In The Matter West Melton - Plan Change 74

OFFICER COMMENTS OF SHANE BISHOP

Existing West Melton Water Supply – Scheme layout

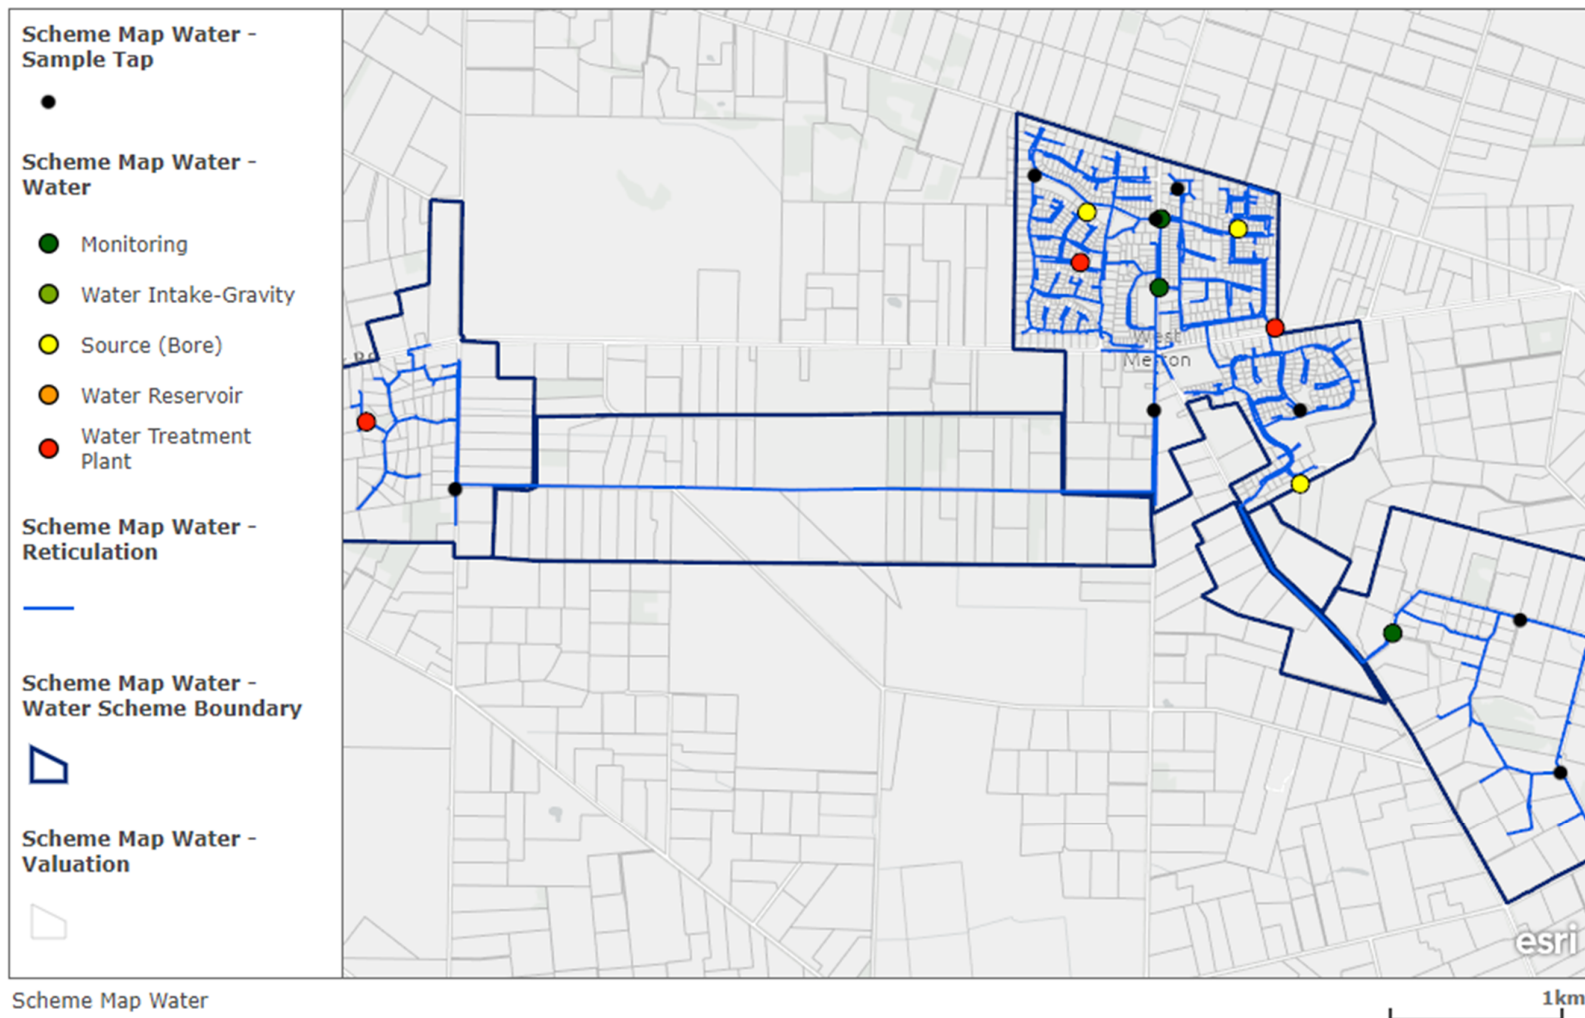
8. The water supply generally provides on-demand' connections via water meters with the exception of Johnson Road being a metered tank supply and a number of properties in West Melton are supplied through a restricted connection (**Refer Appendix 1**).

West Melton Water Supply – Planned Upgrades

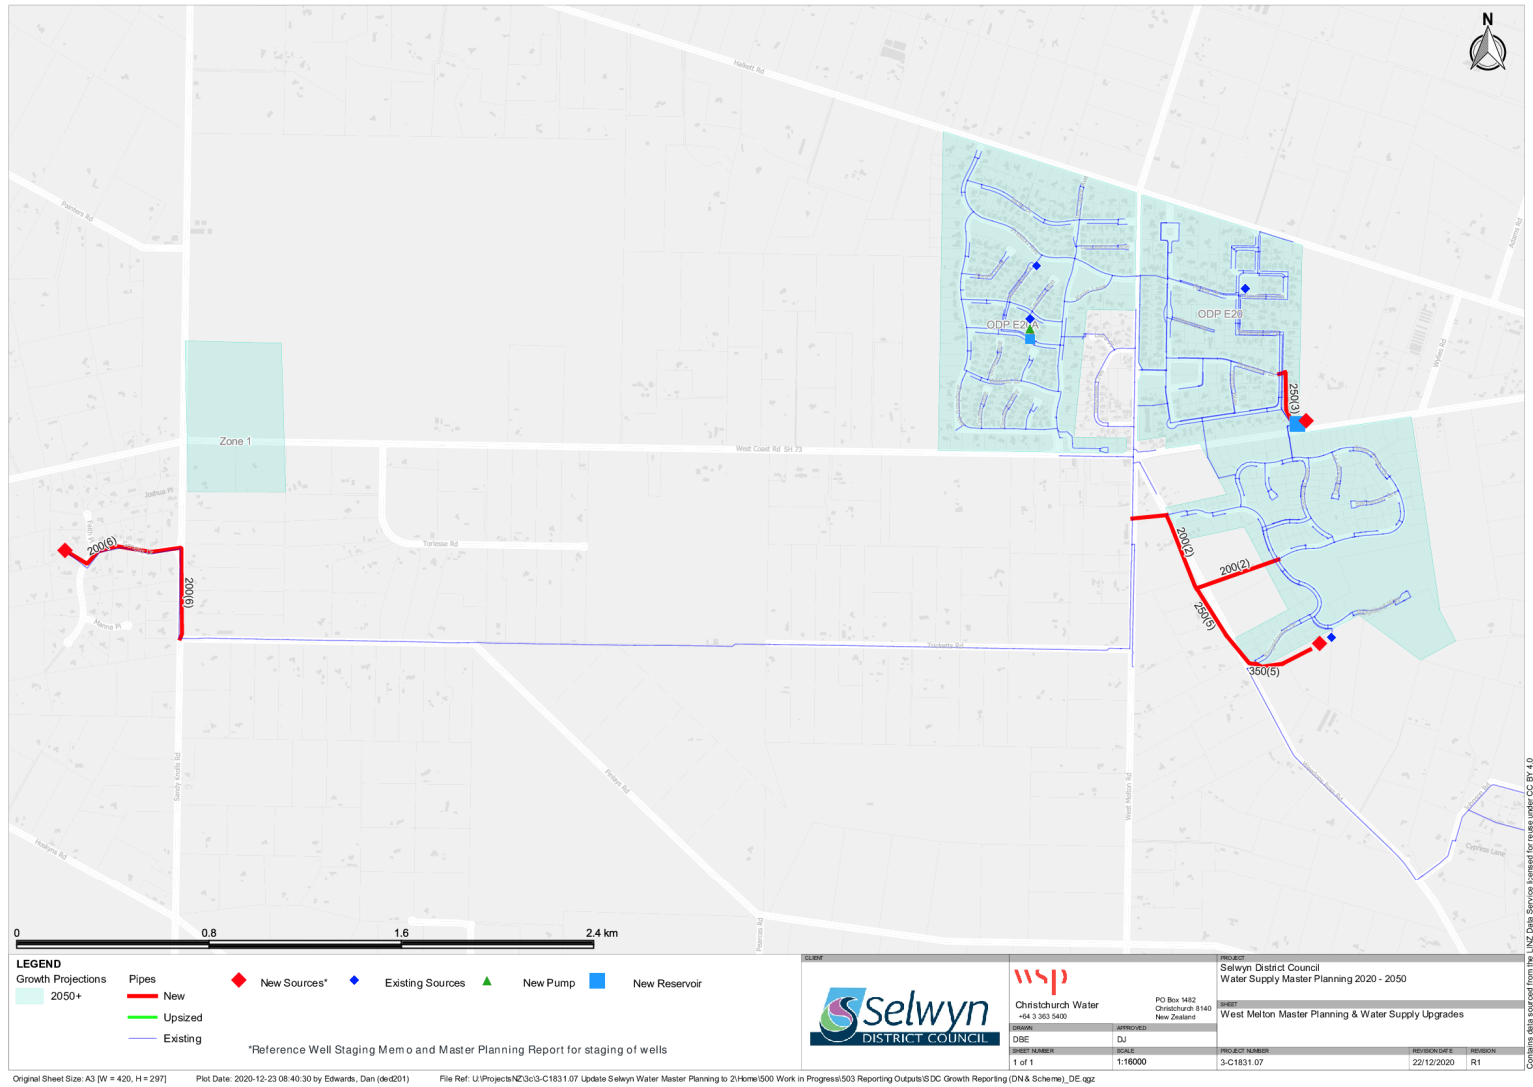
16. The master planning provides an assessment of the sizing and timing of new infrastructure for new reservoirs, water sources (bores) and pipelines to service growth. Part of the master planning requires a water balance to be developed to forecast growth, using historical peak demand per household. The water balance forecasts the peak instantaneous flow per year versus the water resources available to determine the staging of new bores (**Refer Appendix 1**).

Existing West Melton Wastewater Network - Community

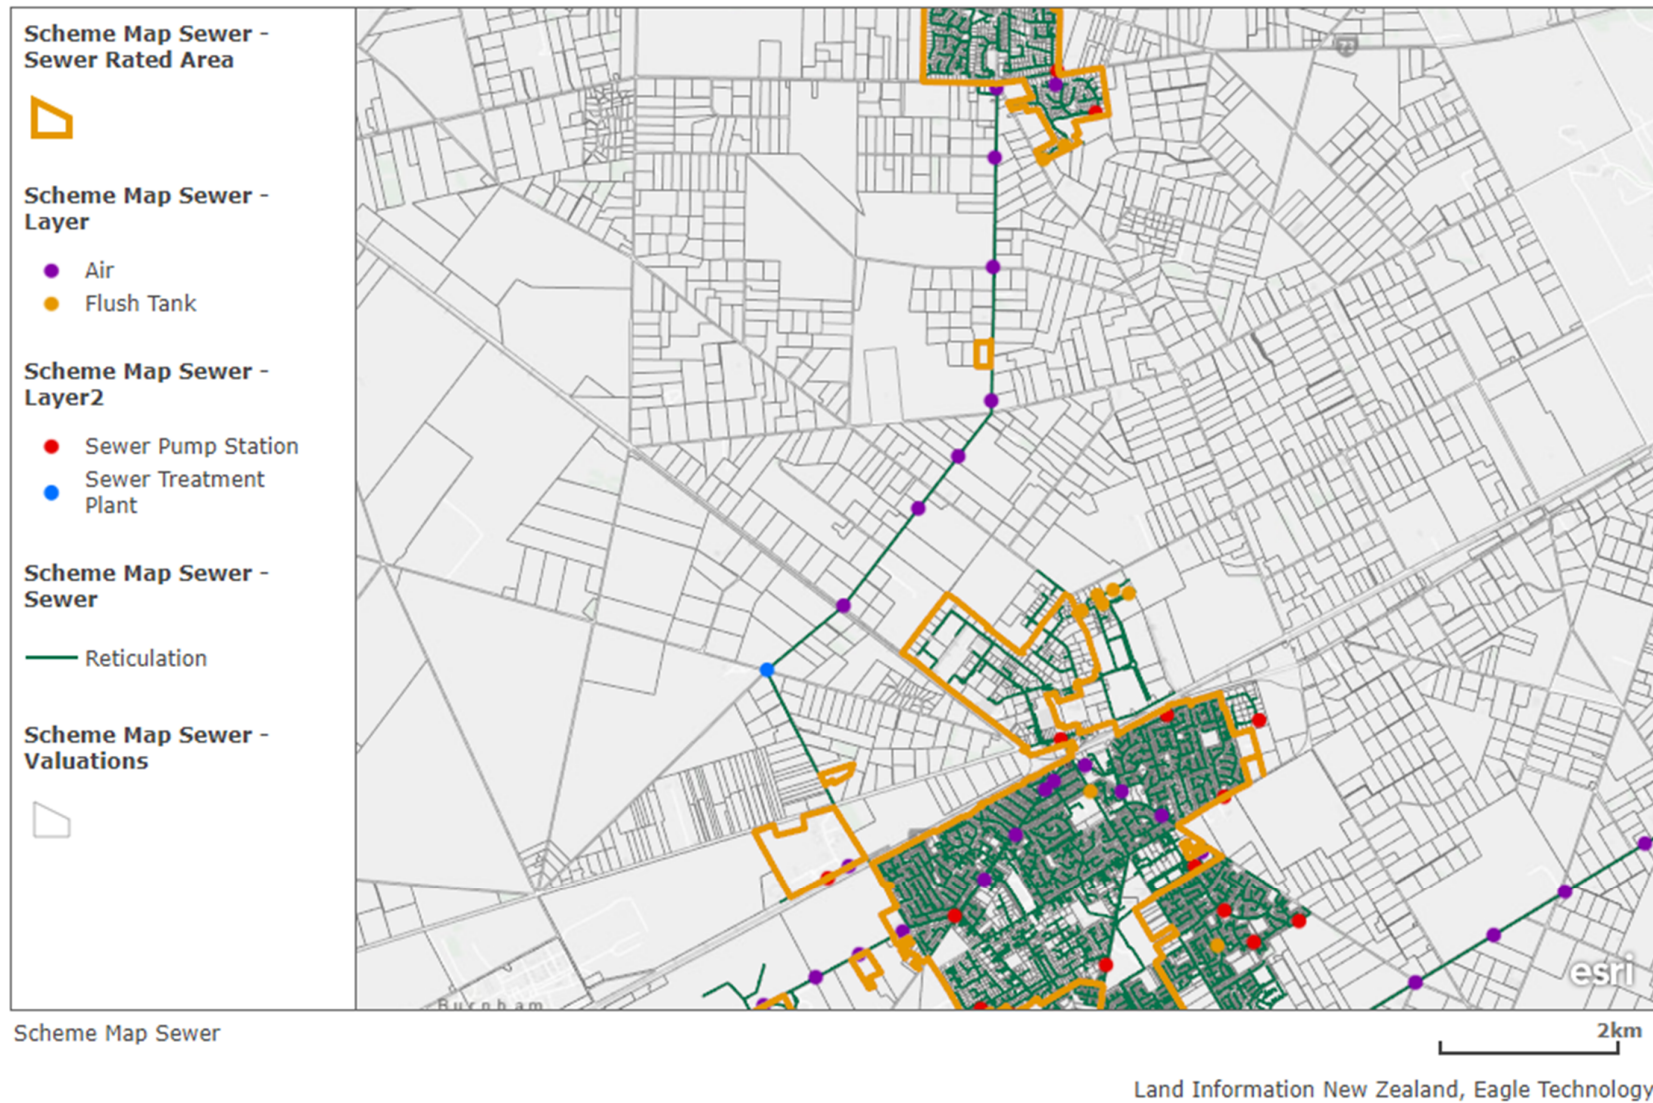
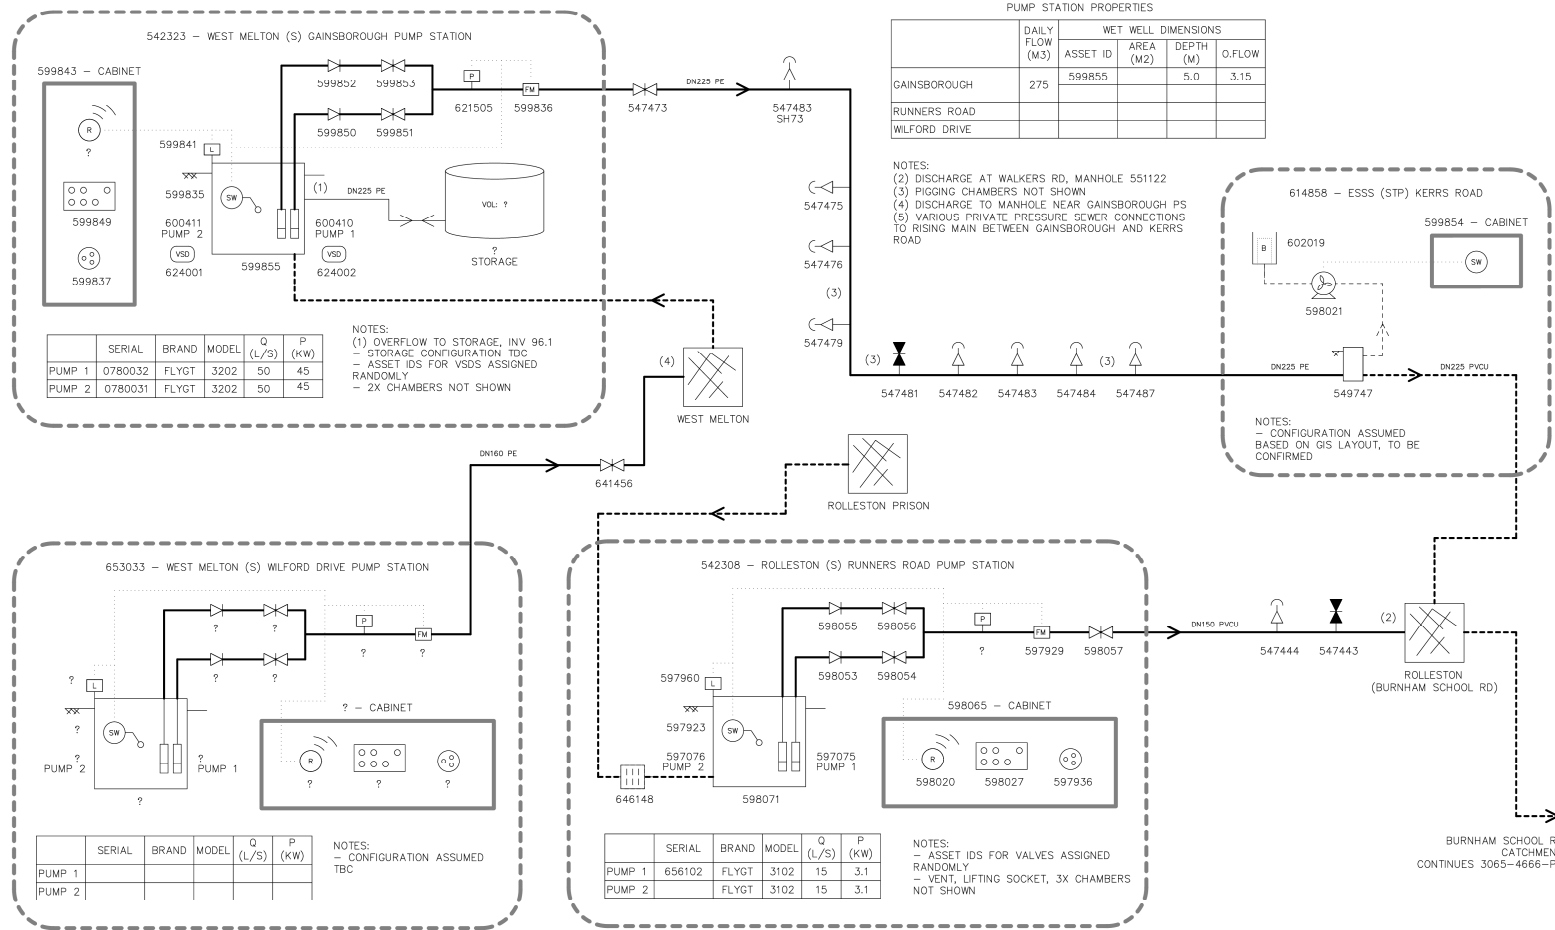
28. Conveyance of the existing wastewater system for West Melton is principally via gravity to catchment pump stations. All flows are conveyed to the current terminal pump station (Gainsborough Pump Station in Rossington Drive) which then pumps wastewater to Councils gravity manhole located at the intersection of Walkers and Runners Roads. Wastewater from West Melton ultimately discharges to the Pines Wastewater Treatment Plant (Pines WwTP) in Rolleston (**refer Appendix 2**).
